PCN# 20250110001.2A

**Bond wire removal and datasheet update for select F65 devices
Change Notification / Sample Request**

Date: June 25, 2025

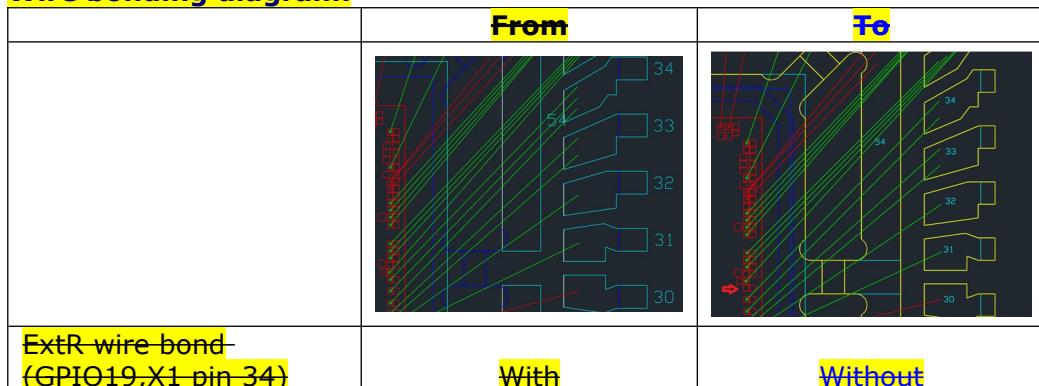
PCN Revision A is to announce the retraction of the ExtR wire bond change from this notification.

Remove ExtR wire bond (pin 34- GPIO19,X1) and data sheetn update for the products listed in the "Product Affected" section of this document.

Construction differences are as follows:

Wire-bonding diagram:
